**KNOXVILLE/KNOX COUNTY METROPOLITAN PLANNING COMMISSION
 USE ON REVIEW REPORT**

▶ **FILE #:** 2-A-14-UR

▶ **APPLICANT:** HARDEE'S RESTAURANTS, LLC

▶ **PROPOSED USE:** Restaurant

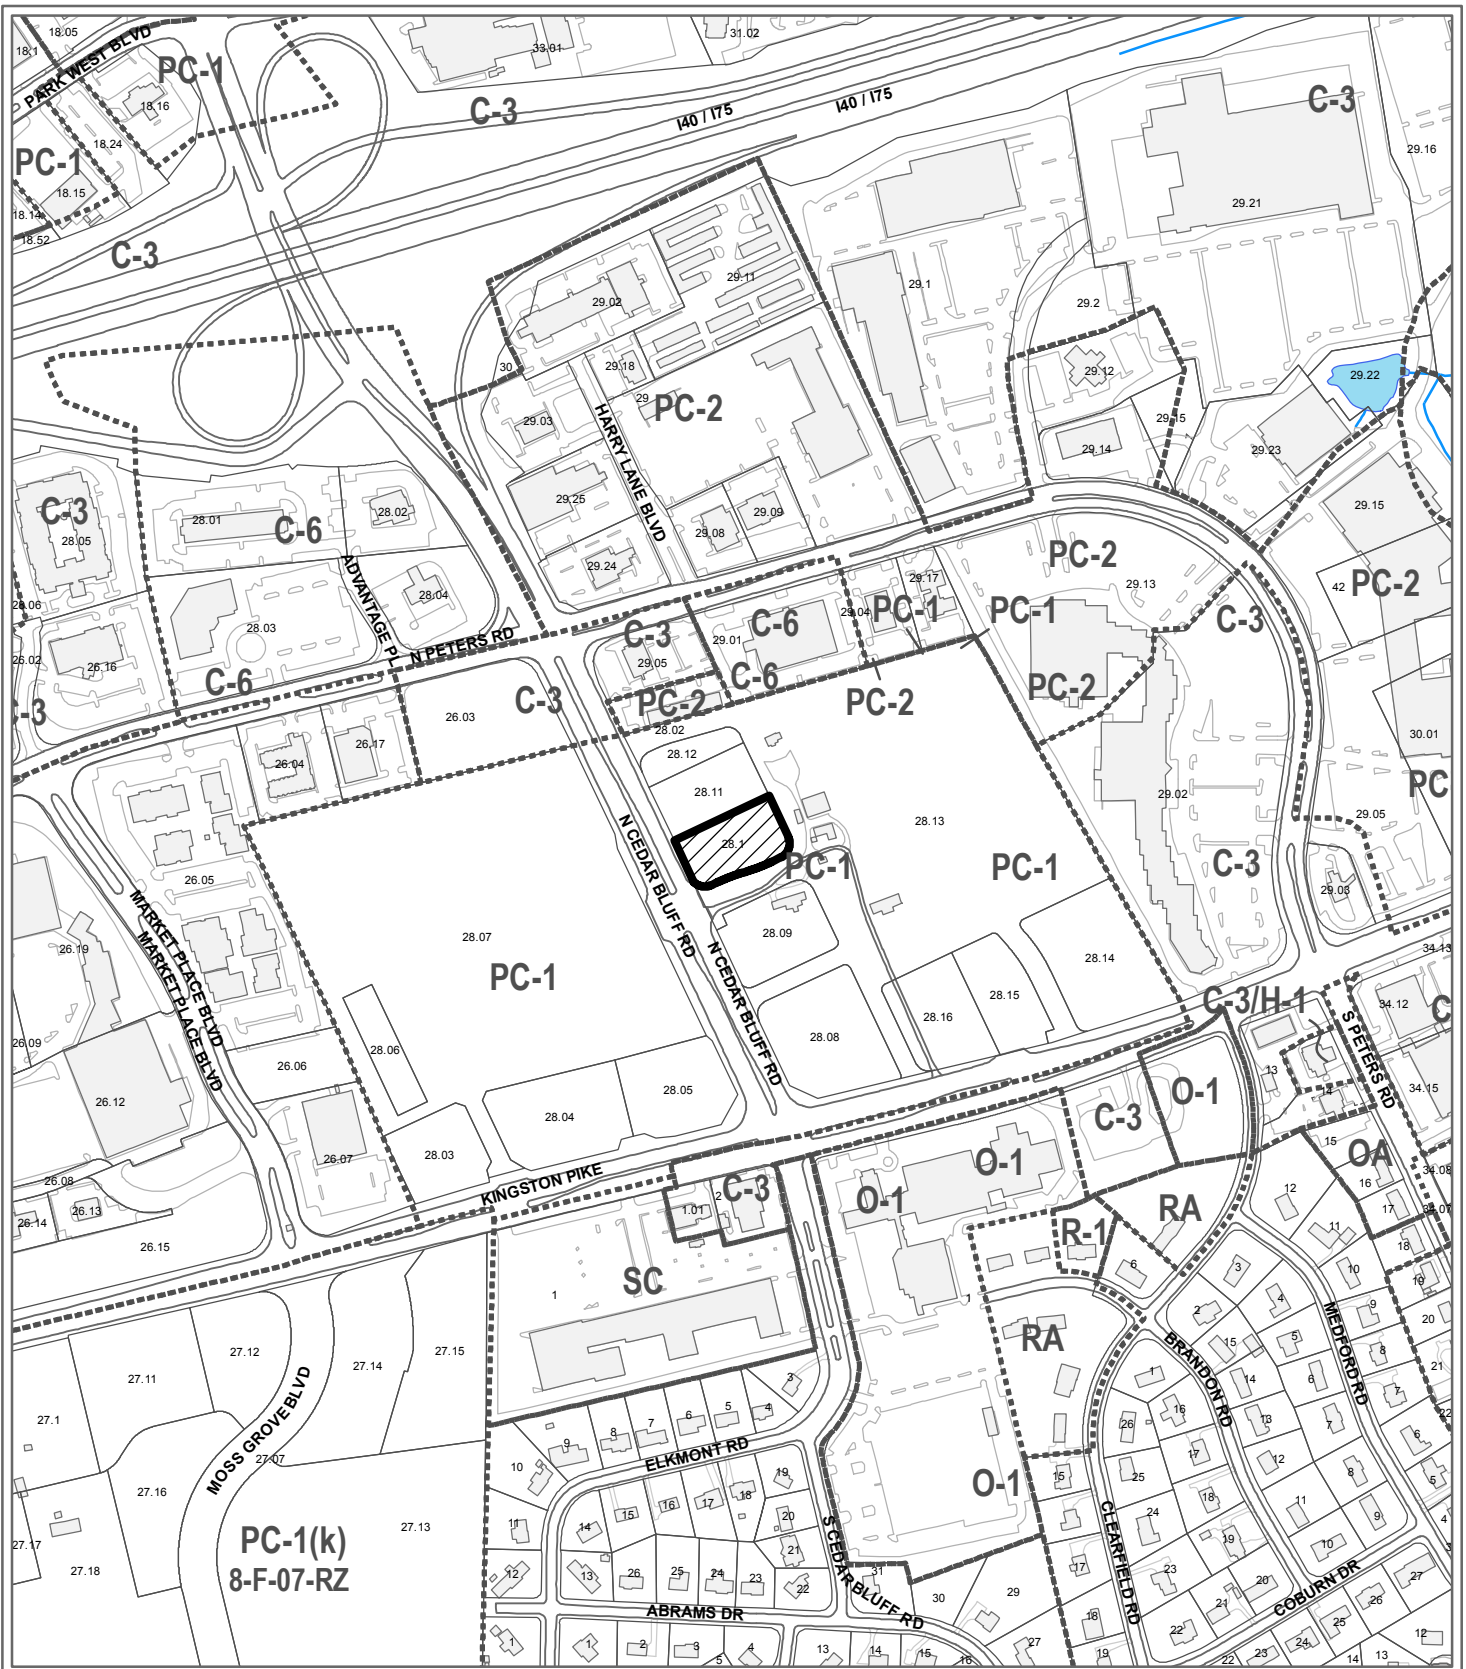
▶ **APPROVE the request for a restaurant containing approximately 3,037 square feet of floor area as shown on the development plan, subject to 9 conditions**

1. Connection to sanitary sewer and meeting any other relevant requirements of the Knox County Health Department.
2. Meeting all applicable requirements of the Knoxville Zoning Ordinance

3. An occupancy permit shall not be issued for this development until the internal access driveways serving the Kingston Corner Commercial Subdivision and any required off-site street improvements are installed by the developer and approved by the Knoxville Department of Engineering. If the driveway and street improvements are phased for the subdivision, the access driveways that adjoin this site must be completed prior to issuance of the occupancy permit.

4. An occupancy permit shall not be issued for this development until the stormwater facilities serving the Kingston Corner Commercial Subdivision and this proposed development are installed by the developer and approved by the Knoxville Department of Engineering.

5. Obtaining approval from the Knoxville Department of Engineering on the final design details for the right-in/right-out only access to the main access drive to N. Cedar Bluff Rd. for Kingston Corner Subdivision.

6. Meeting all applicable requirements of the Knoxville Department of Engineering.
7. Installation of landscaping as shown on the landscape plan within six months of the issuance of an occupancy permit for this project.

8. Meeting all applicable requirements of the Knoxville City Arborist.
9. Proposed signage subject to approval by the Planning Commission staff and Knoxville's Sign Enforcement Inspector.

The applicant is proposing to develop a Hardee's restaurant with approximately 3,037 square feet of floor area on a 0.95 acre lot that is a part of the Kingston Corner Commercial Subdivision. The site is located on the east side of N. Cedar Bluff Rd., north of Kingston Pike. While the lot has frontage along N. Cedar Bluff Rd., there will be no direct access from the site to the arterial street. Access to the site will be through the driveway network for the commercial subdivision which provides access to N. Cedar Bluff Rd. and Kingston Pike. The lot is located on the north side of the main access drive to N. Cedar Bluff Rd. at the signalized intersection.

Stormwater management for this site will be tied into the overall stormwater system for the subdivision. The applicant has submitted plans for a 12' high monument sign for the restaurant along the N. Cedar Bluff Rd. frontage.
